## Response to Comments of Parties

Ameren Missouri – 2011 Integrated Resource Plan

Company Exhibit No. 2 NP  
Date 12/15/11 Reporter JMB  
File No. EO-2011-0271

**Figure 2.4 Cumulative Peak Demand Savings**

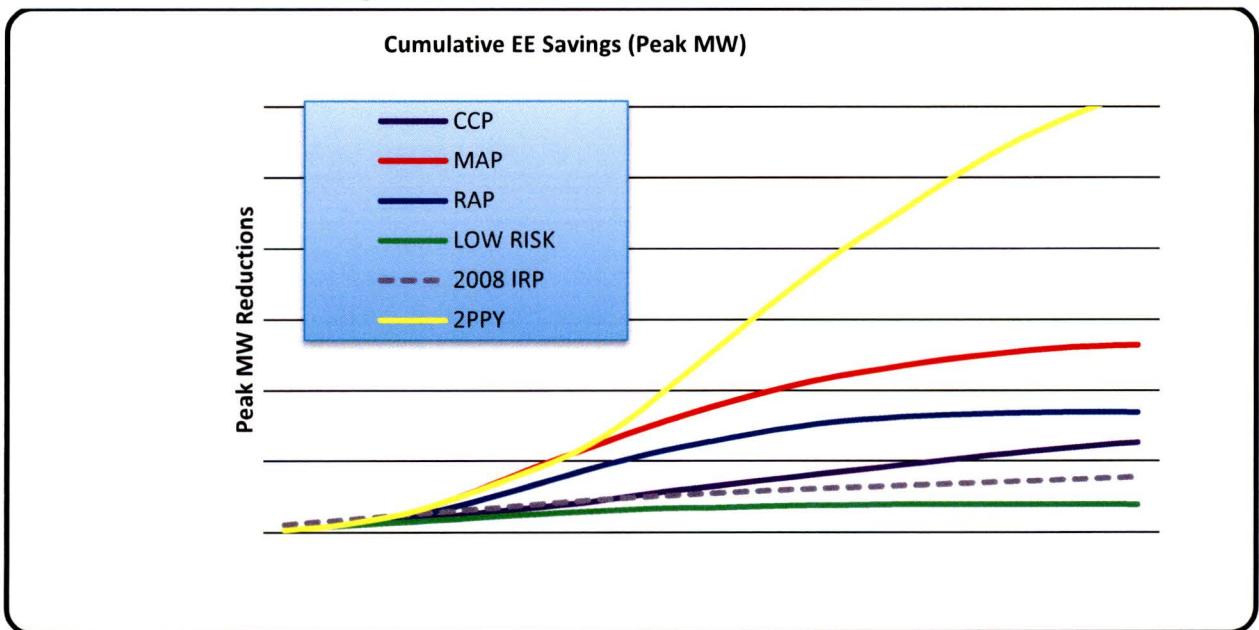
**Issue Summary:** OPC asserts that Ameren Missouri did not develop alternative resource plans that capture the full range of demand-side resources, citing 22.010(2)(A), which requires evaluation of demand-side resources on an equivalent basis with supply-side resources, and 22.060(3), which requires the development of a range of alternative resources plans designed to achieve one or more planning objectives. OPC contends that Ameren Missouri did not consider a sufficient range of demand-side resource portfolios and that the lack of more portfolios to analyze restricts minimization of PVRR. OPC further asserts that the RAP portfolio underestimates the amount of energy savings that could be achieved by assuming what OPC considers to be low financial incentives to participating customers and low awareness of the efficiency programs, two parameters over which it states the Company has control. Finally, OPC contends that Ameren Missouri has not complied with the Commission’s order in Ameren Missouri’s 2008 IRP (Case EO-2007-0409) which required the Company to “model an even more aggressive approach to encourage participation in demand-side management programs in its next filing.”

**Ameren Missouri’s Position and Evidence:** Ameren Missouri has evaluated a broad range of DSM programs and portfolios and has evaluated inclusion of DSM resources on an equivalent basis with supply-side resources. OPC’s assertions disregard the fact that the Company evaluated five different DSM portfolios – MAP, RAP, Low Risk, CCP, and 2% load reduction, that all but the Low Risk portfolio result in greater demand and/or energy savings than that included in Ameren Missouri’s 2008 IRP, and that a comparison of the RAP and CCP portfolios provided a rigorous test of different mixes of energy efficiency and demand response resources.

Figure 2.2, presented previously in this report, shows that energy savings for the RAP portfolio are roughly equivalent to those included in Ameren Missouri's 2008 IRP, while energy savings for the MAP and 2% annual load reduction portfolios are significantly higher. Figure 2.4 shows that demand savings are greater for the RAP, MAP, CCP and 2% annual load reduction portfolios than that for the 2008 IRP portfolio.

**Figure 3.3 Projected Meramec Capex from Burns and McDonnell Condition Assessment**  
**Figure 21 – Projected CAPEX through 2041 (Then-Year \$'s)**

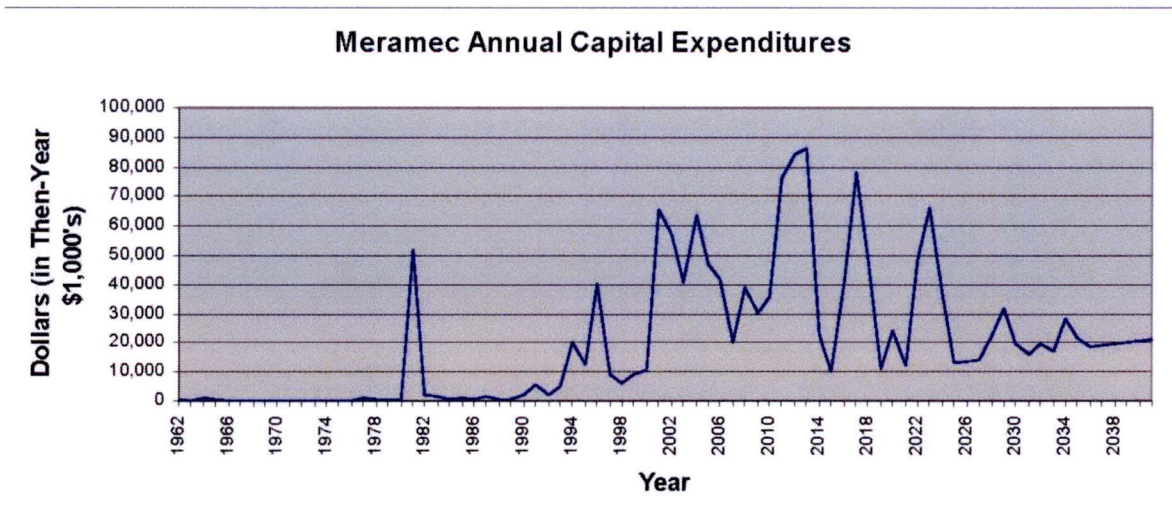
NRDC asserts that Ameren Missouri has inappropriately assumed that the capital and operating costs for the Meramec plant will decrease rather than increase as the units age. As shown in Figure 3.3 below, the forecast assumptions for capital costs include specific major projects during the 2011-2025 timeframe, as detailed in the Burns and McDonnell report, and an increasing level of baseline capital expenditures thereafter.

NRDC questions the future capital and O&M budgets developed by Burns and McDonnell based on comparisons to recent history. This kind of comparison is not valid because Ameren Missouri has made significant investments in major component replacement and refurbishment in recent years that will not have to be made again for the remaining life of the plant. For example, the unit 4 turbine was replaced in 2005 and would not have to be replaced again even in the 2041 retirement scenario. In the Meramec Condition Assessment Report, Burns and McDonnell included a comparison of historical capital and O&M expenditures to forecasts for the scenarios evaluated. They explicitly address the comparison in the following narrative from page 115 of the report:

Figure 3.4 does not indicate any upward trend of "significant" costs which would indicate a deterioration of the plants as they age. The charts of Equivalent Availability Factors on the following pages do not indicate any downward trend in EAF which would indicate a deterioration of plants as they age. Thus, Ameren Missouri maintains that there is no evidence to conclude that O&M costs increase dramatically or that performance decline significantly as the plants age.

Conclusion: Ameren Missouri's assumptions with respect to the ongoing costs and operation of the Meramec plant are reasonable, and Ameren Missouri has complied with the rules governing the development of cost and performance assumptions for supply side resources in accordance with 22.040(1).

**Figure 10.1 Lost Revenue Impact on Earnings by Rate Case Frequency**

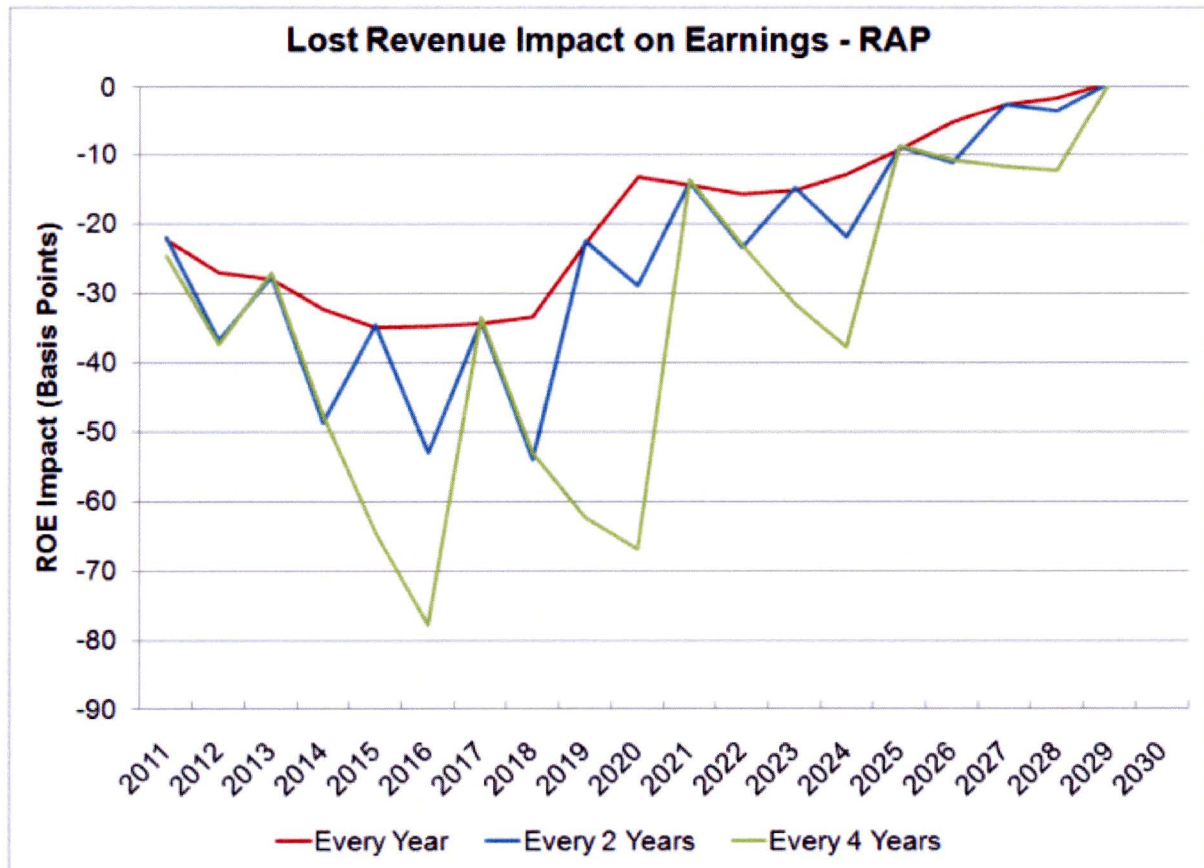
Ameren Missouri's Position and Evidence: Ameren Missouri has documented the subjective probabilities for uncertain factors as required by 22.070(1), has performed the preliminary sensitivity analysis required by 22.070(2), and has documented the values and probabilities for uncertain factors as ordered by the Commission in EO-2007-0409. A discussion of the uncertain factor ranges is presented in Chapter 9 of Ameren Missouri's IRP filing, beginning on page 15. NRDC's connection of requirements for evaluation of uncertain factors to the Company's analysis of lost revenue is nonsensical.

Ameren Missouri has clearly established through explicit analysis the harmful financial effects of lost revenues and has set an appropriate range for allowed ROE for the planning horizon. NRDC's assertion that the Company has not proven that lost revenues would result in ROE deterioration completely ignores the results of the Company's explicit analysis of this issue presented in Chapter 10 of the IRP filing and supported by detailed workpapers. Figure 10.1 below shows the impact on ROE due to lost revenues under a plan that includes the RAP DSM portfolio for several different assumptions of rate case frequency.

As can be seen, the impacts on ROE can be significant even with annual rate cases. This same chart was presented in the Company's IRP filing in both Chapter 1 (Figure 1.10, page 17)) and in Chapter 10 (Figure
